DELEGATED DECISIONS BY CABINET MEMBER FOR TRANSPORT MANAGEMENT

14 NOVEMBER 2024

STANDFORD IN THE VALE: A417 FARINGDON ROAD – PROPOSED HIGHWAY IMPROVEMENTS

Report by Director of Environment and Highways

DRAWING NO: Toucan Crossing Consultation Plan

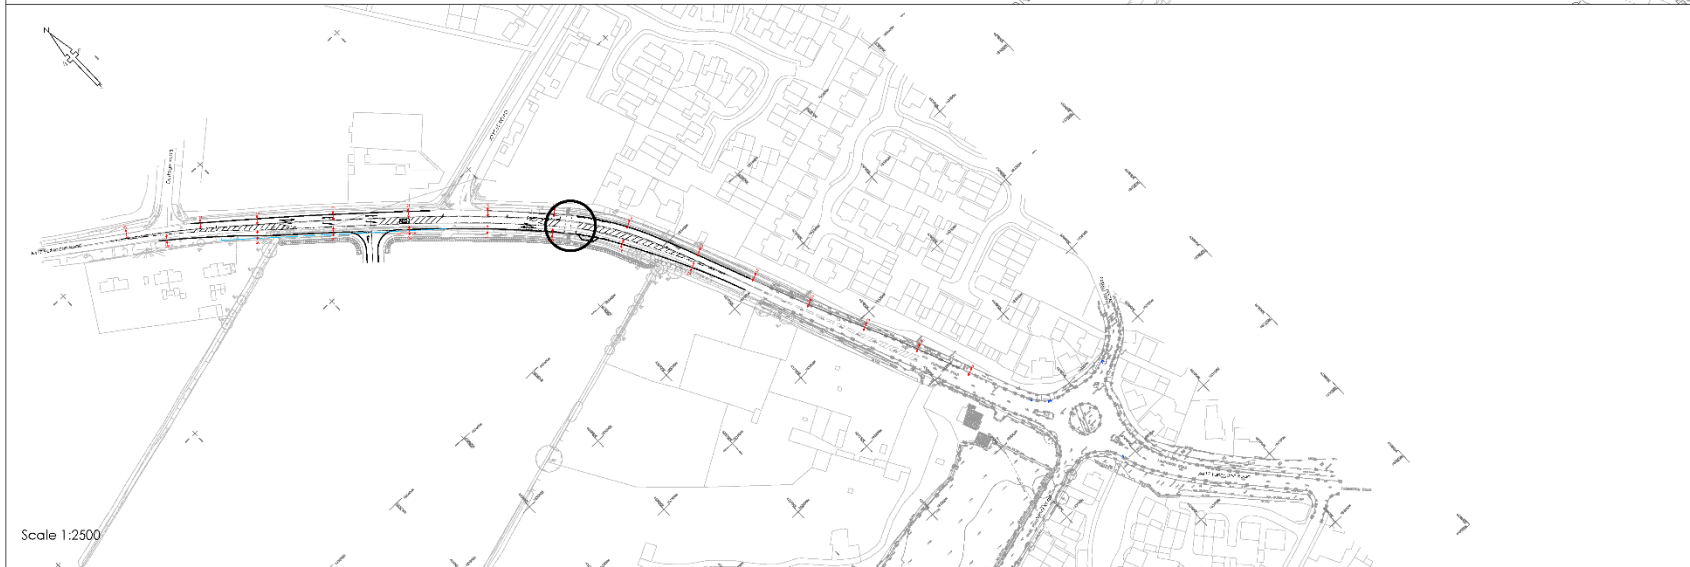
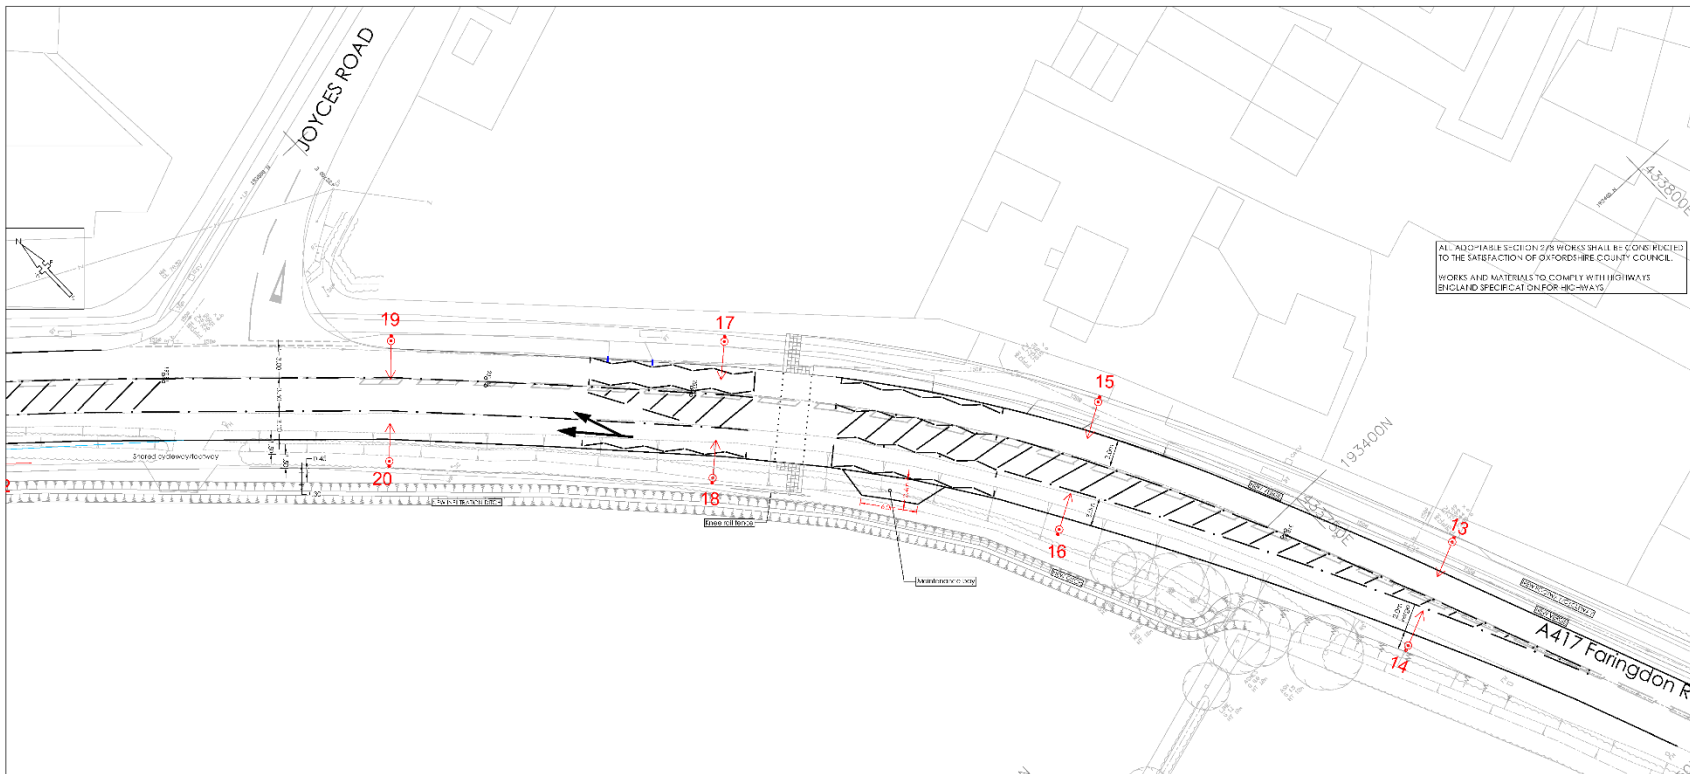
<p>Toucan crossing – Support I do agree the proposed position as it will cause light pollution and cause excessive noise outside our property. The position should be near the access road to River Meadow as this is the location most residents use to cross the main A417 road.</p> <p>Shared-use foot & cycle paths – Object The cycle path is proposed to run directly across our driveway which is on a slope and we are unable to have clear vision for the large increase the path will cause with pedestrians and cycle traffic. There is a major health and risk and an accident waiting to happen as no provision for this risk has been considered by OCC highways.</p>
<p>(18) Local resident, (Stanford in the Vale, Joyces Road)</p>	<p>30mph speed limit – Support This has taken far too long to reach this stage. I have wondered at the 40 mph limit for many years - so please, 30 mph can't come soon enough!</p> <p>Toucan crossing – Support I understand a safe crossing is essential now that there are so many new houses in Stanford. I'm just surprised this wasn't included in the original planning request for the new estates.</p> <p>Shared-use foot & cycle paths – Object I'm concerned for the safety of pedestrians - already very little thought seems to have been given to the safety of pedestrians with the location of the new crossing points put in for crossing Ware road and Joyces Road. These all mean that pedestrians are expected to cross the road "blind", i.e. with no sight of oncoming traffic. Personally, I won't use them - I walk further down the road on the grass verge to get the view I need.</p>

<p>We feel the position of the crossing is not suitable. It has been placed in a close proximity to three entrances (2 homes and 1 allotment access) also a lot of the allotment holders use the grass verge for parking and have done form decades. The crossing would be better located along by the football field and the majority of the residents use Joyce's Road to gain access into the village.</p> <p>Shared-use foot & cycle paths – Object We are not happy with the cycle path running parallel with our concealed driveway, we have made a lot noise about this especially as we have to accelerate out of our drive due to our property being so much lower than the foot & cycle paths. We feel this has placed us in a dangerous situation and could result in someone being injured. Not a nice position to be place in and could lead to us being prosecuted not to mention living with the fact we could seriously injure or kill someone!</p>

24. Response no.17 – The design of the cycleway has taken in to consideration the driveway and has been subject to a stage 2 road safety audit. Once complete, the works are also subject to a stage 3 road safety audit, and if any additional matters are raised, they will be addressed.

25. Response no.19 – The design of the cycleway has taken in to consideration the driveway and has been subject to a stage 2 road safety audit. Once complete, the works are also subject to a stage 3 road safety audit, and if any additional matters are raised, they will be addressed. The design has been adjusted to provide additional visibility for the driveways that are lower than the highway.

Section 278 Works: Traffic Regulation Order - Cycleway

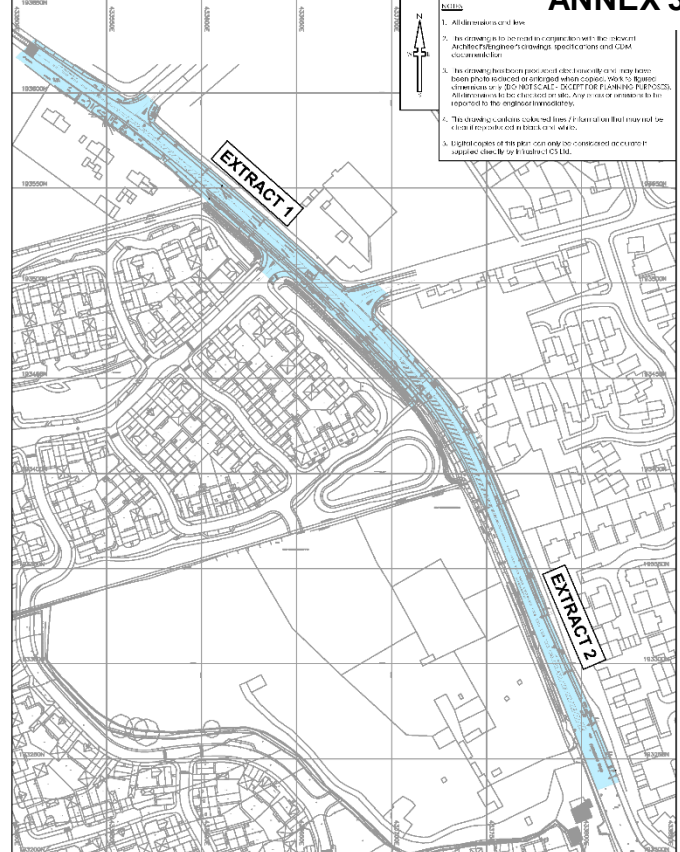
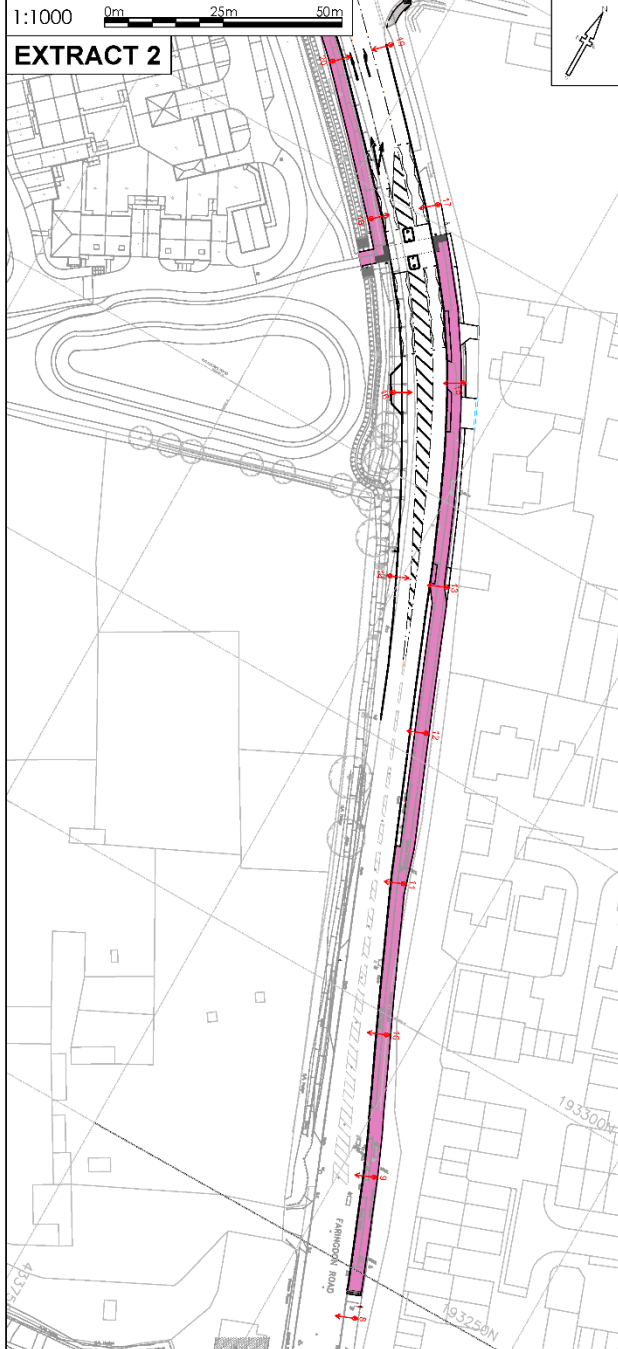
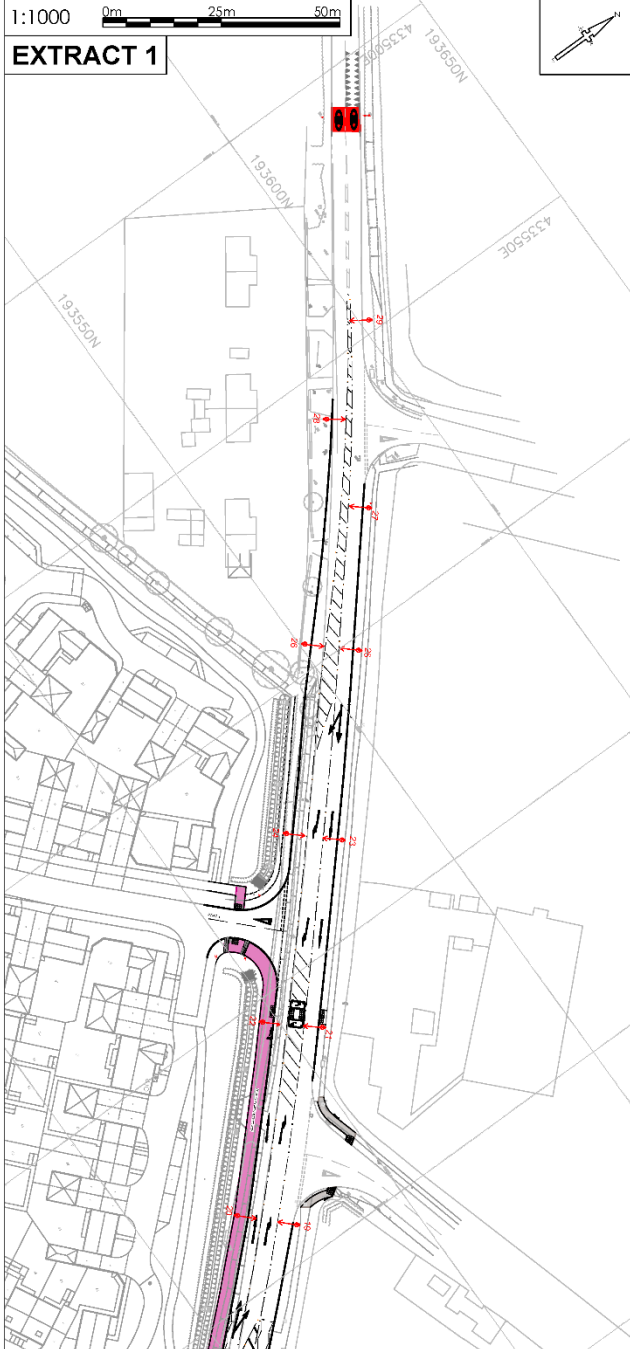
23. Response nos.16 & 18 – Shared use footway/ cycleways are widely used throughout Oxfordshire and the nation. The route is being widened to accommodate the inclusion of cycleway on the shared route. Adequate visibility, signage and lighting is proposed as part of the works to alert pedestrians and cyclists using the link.

22. The consultation plan indicates where the footway/ cycleway is proposed and can be provided for users. The location was consulted and reviewed through the planning process and subsequent Section 278 application.
